### **Response to Comment C35-42 (continued)**

Letter - C35  
Page 22

Figure 3.1-2 Historic Change in Elevation and Salinity of Salton Sea

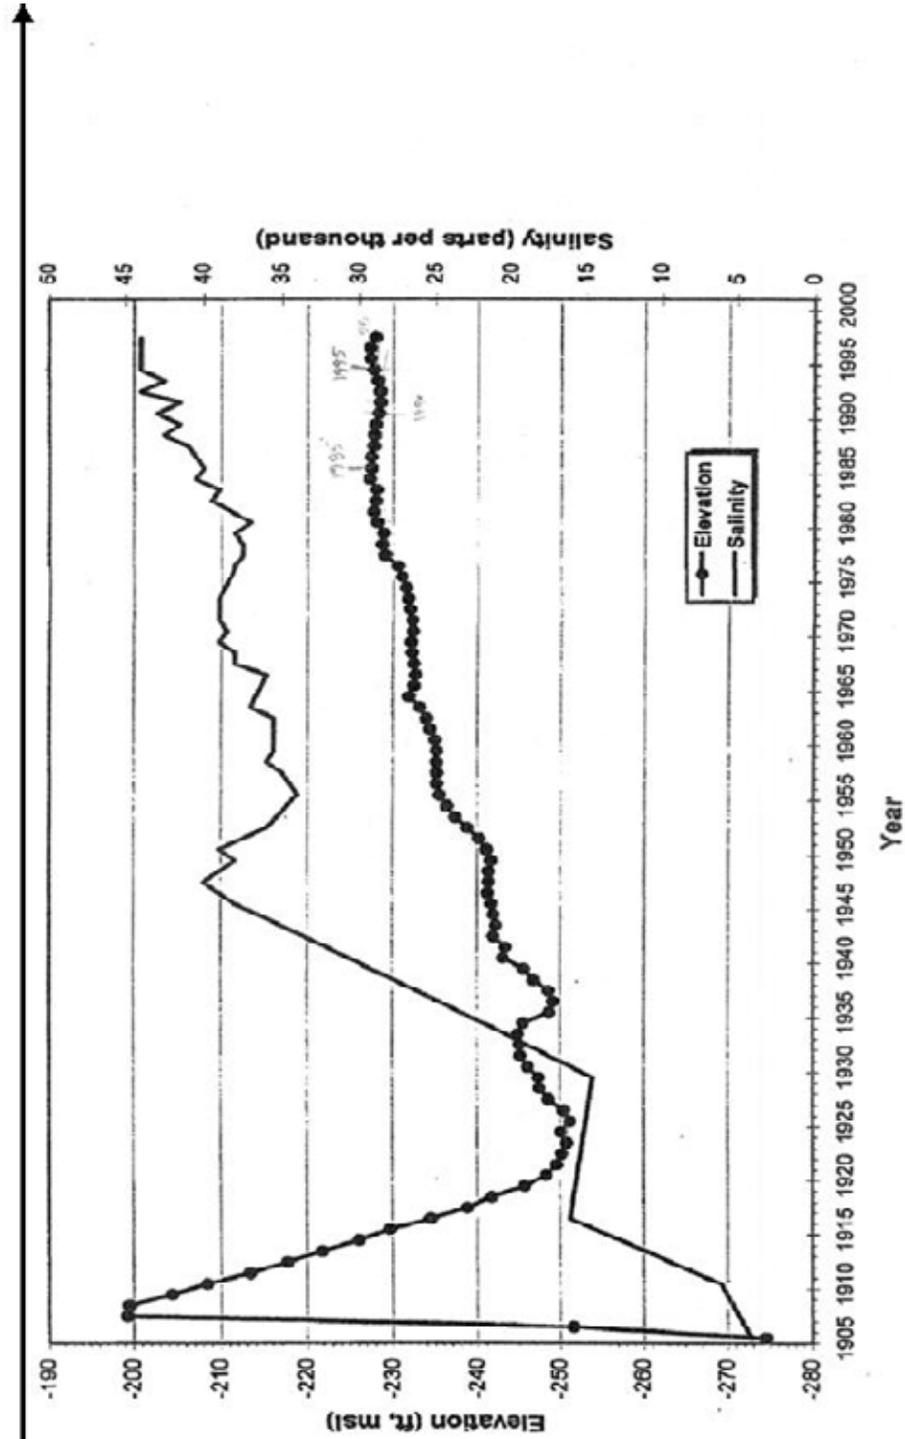
Another interesting analysis from the drainage data shown in Figure 3.1-14 is the effect Salton Sea surface elevation. Figure C3.1-1: Historic Change in Elevation and Salinity of Salton Sea (Source: [www.lc.usbr.gov](http://www.lc.usbr.gov): Salton Sea Restoration Draft EIR/EIS) shows the surface elevation decreasing over the interval 1986 to 1992 and increasing for the interval 1993 to 1998, with no net change in surface elevation. Averaging the discharges of the two time intervals, states that an IID drainage flow to the sea of 986 KAFY, coupled with an average flow from Mexico of 167 KAFY (plus the CVWD and Unmeasured inflows) will keep Salton Sea surface elevation constant. It is noteworthy that the Baseline (see Section 3.0: Development of Baseline, and my comments on Section 3.0) establishes the long-term IID No Project drainage as 933 KAFY (Source: Appendix E, Table 3-3 IIDSS Simulated Water Balance: calculated by summing the Alamo River, New River, Direct and Subsurface flows and subtracting the Alamo and New River cross border input flows). This is 59 KAFY less than the 12 year (1987 - 1998) historic IID drainage flows of 992 KAFY (Source: same; calculation same) to Salton Sea. I have found no explanation within the Draft EIR/EIS supporting the 59 KAFY shortfall used in setting the No Project Baseline.
